**PLEASANT PRAIRIE PLAN COMMISSION MEETING  
VILLAGE HALL AUDITORIUM  
9915 39<sup>th</sup> AVENUE  
PLEASANT PRAIRIE, WISCONSIN  
6:00 P.M.  
AUGUST 22, 2016**

Consider the request of John Doheny, agent for approval of **Preliminary Site and Operational Plans** for the mass grading, installation of underground utilities and footings and foundations for the construction of a 175,000 square foot industrial building on the vacant land located on the southeast corner of STH 165 (104<sup>th</sup> Street) and 80<sup>th</sup> Avenue in LakeView Corporate Park.

TO: Peggy Herrick, Assistant Planner / Assistant Zoning Administrator  
FROM: John Steinbrink, Jr., P.E., Director of Public Works  
CC: Matthew Fineour, P.E., Village Engineer  
Jean Werbie-Harris, Community Development Director  
SUBJ: **DEV1607-002 DOHENY PRE SITE AND OP**  
DATE: August 1, 2016

THESE PLANS AND DESIGNS ARE COPYRIGHT PROTECTED AND MAY NOT BE USED IN WHOLE OR IN PART WITHOUT THE WRITTEN CONSENT OF PINNACLE ENGINEERING GROUP, LLC

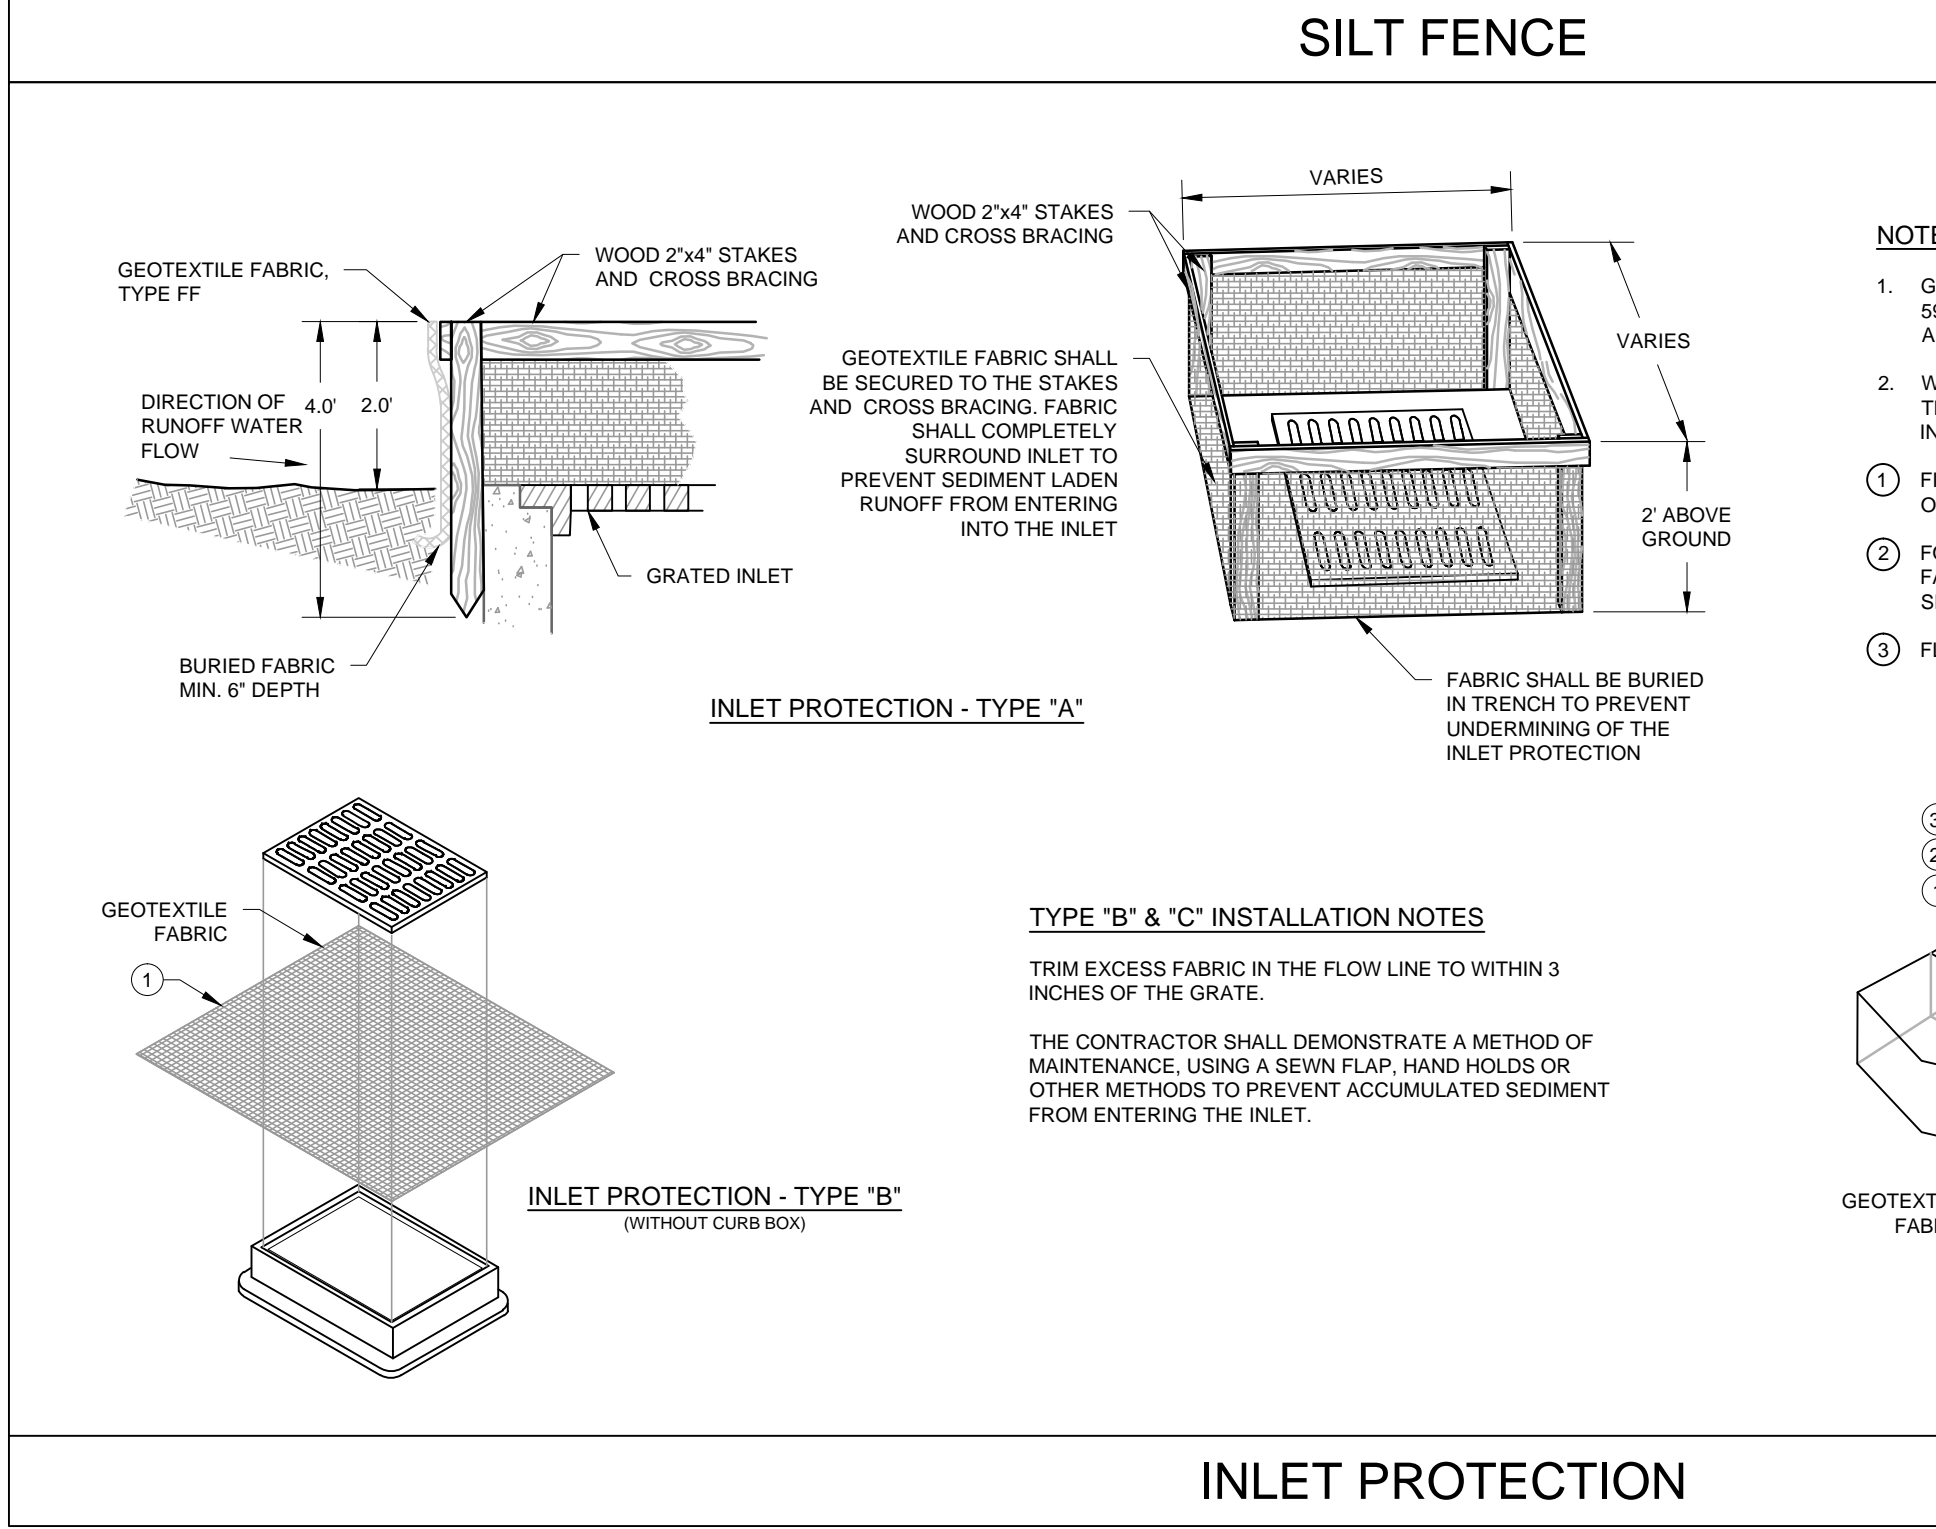
SHOW AND LABEL LOCATION ON THE PLANS

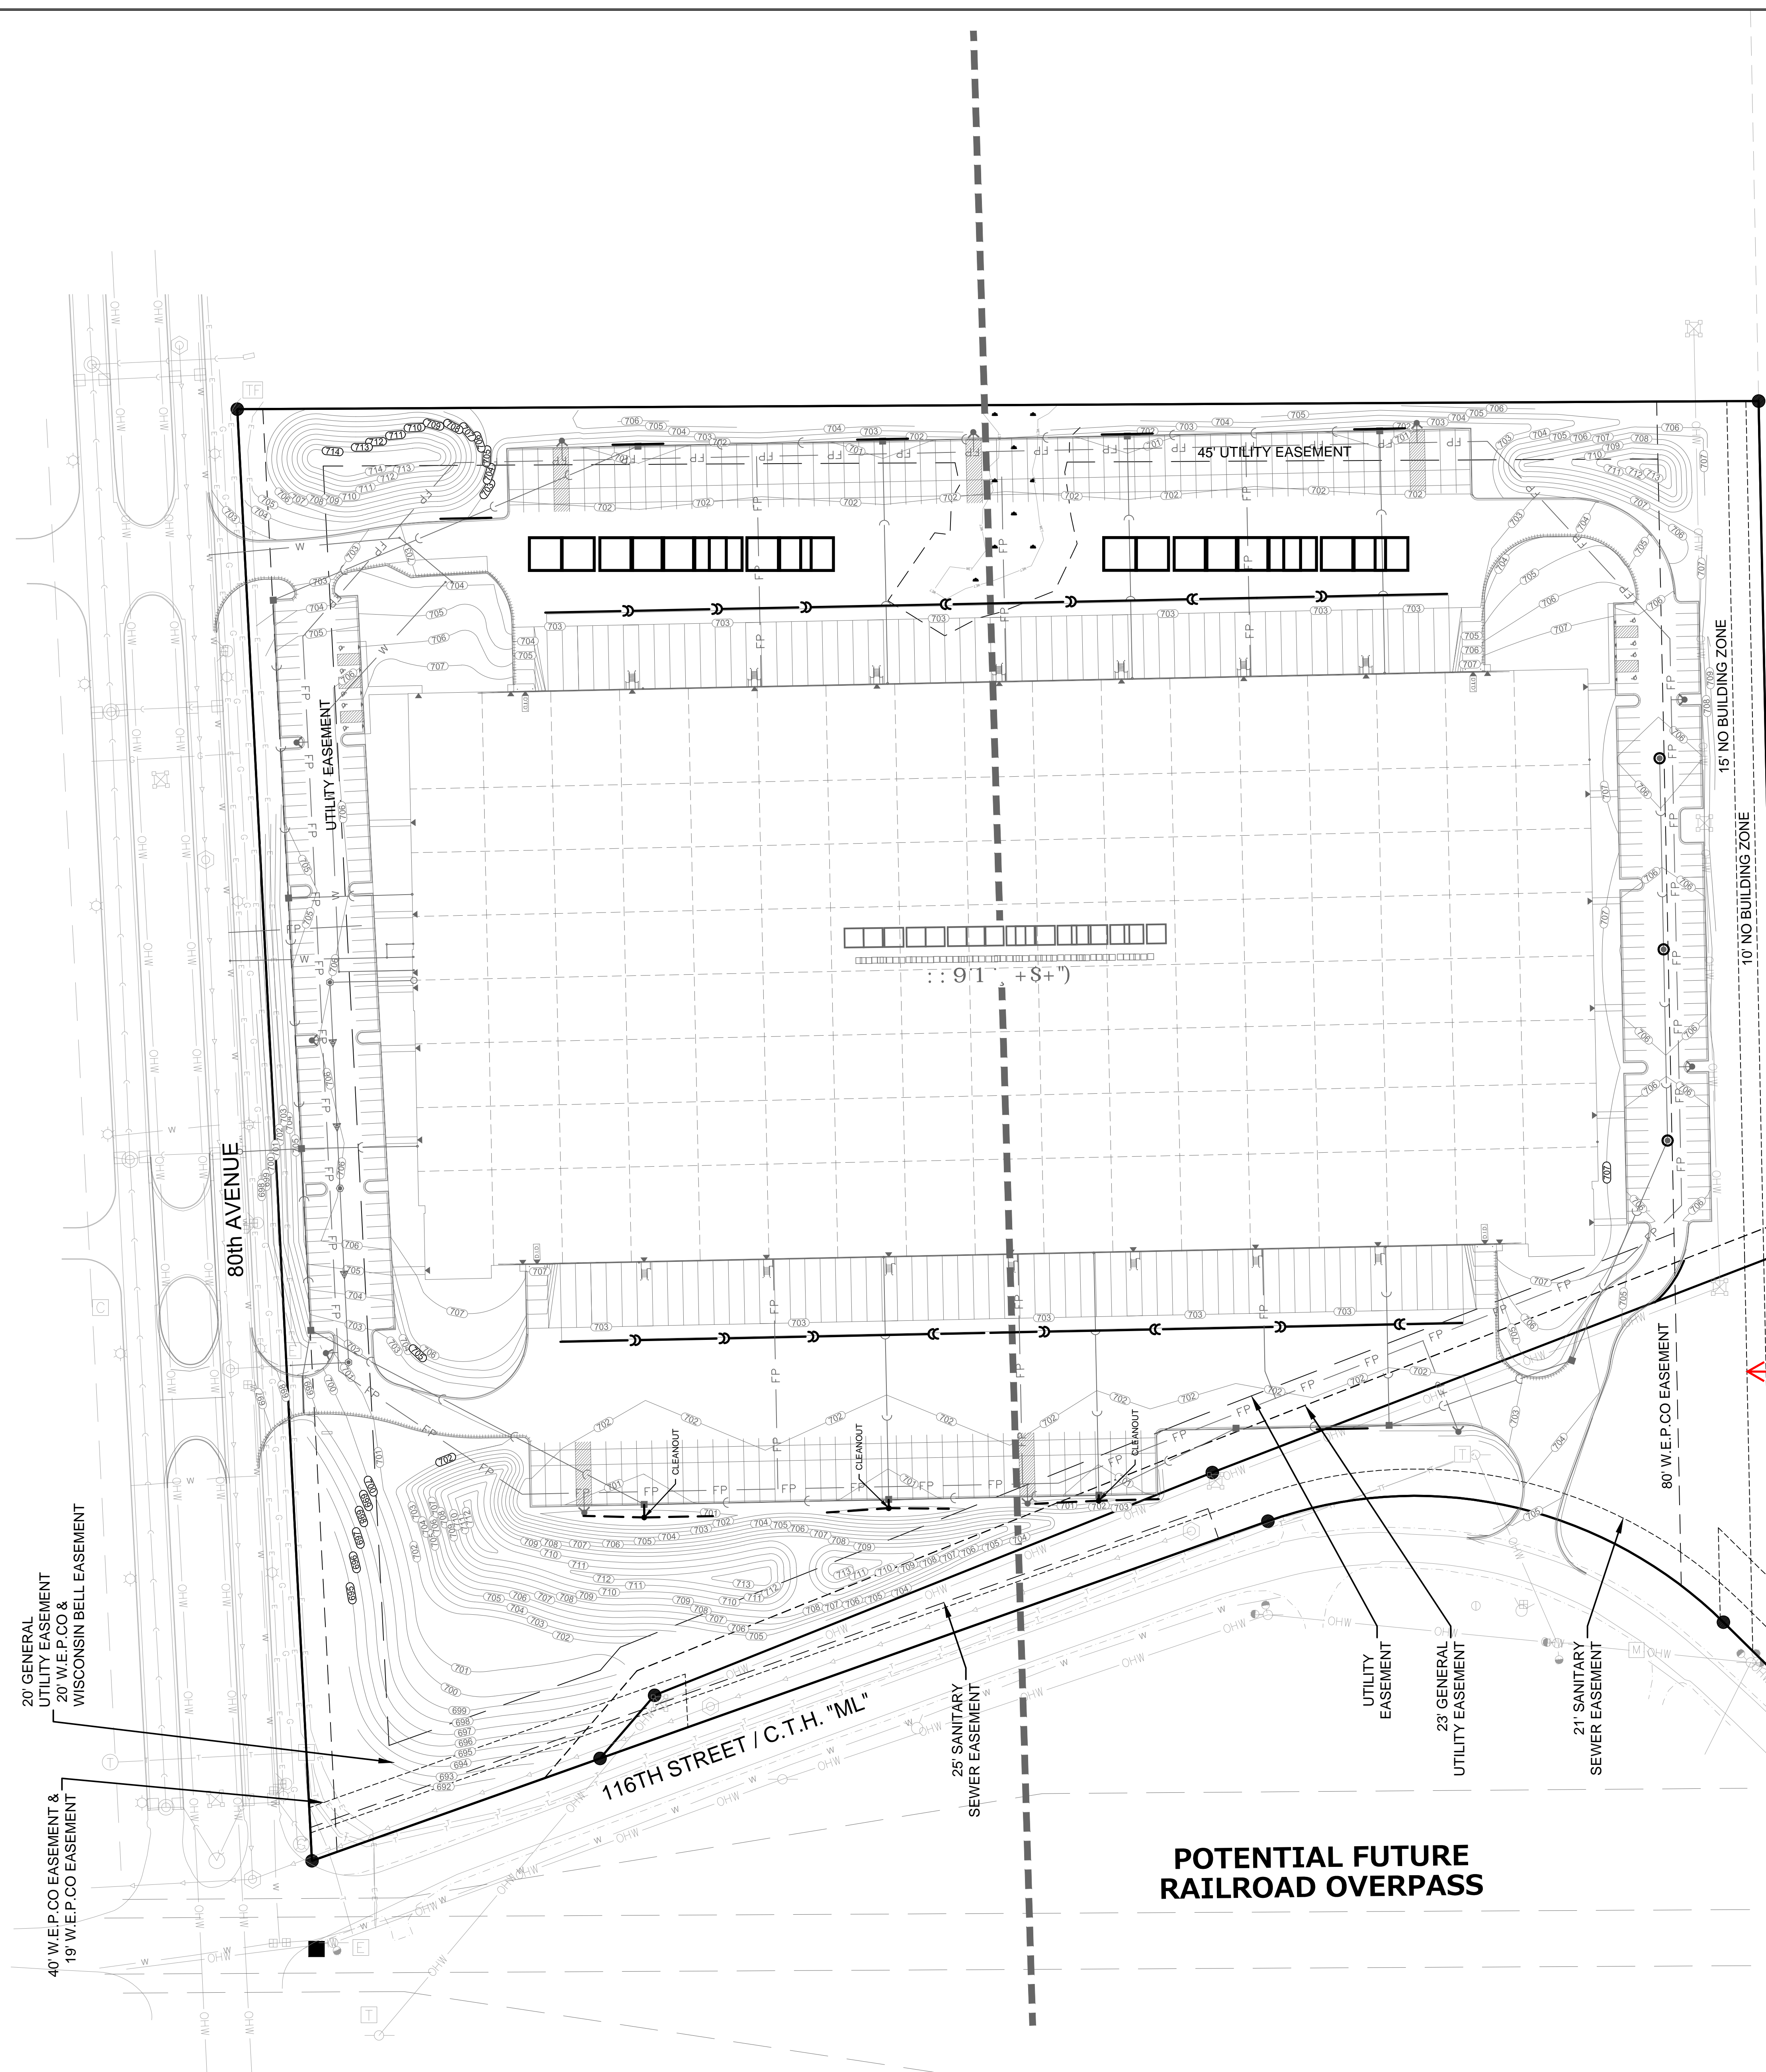
NO CURB INLETS HAVE THIS?
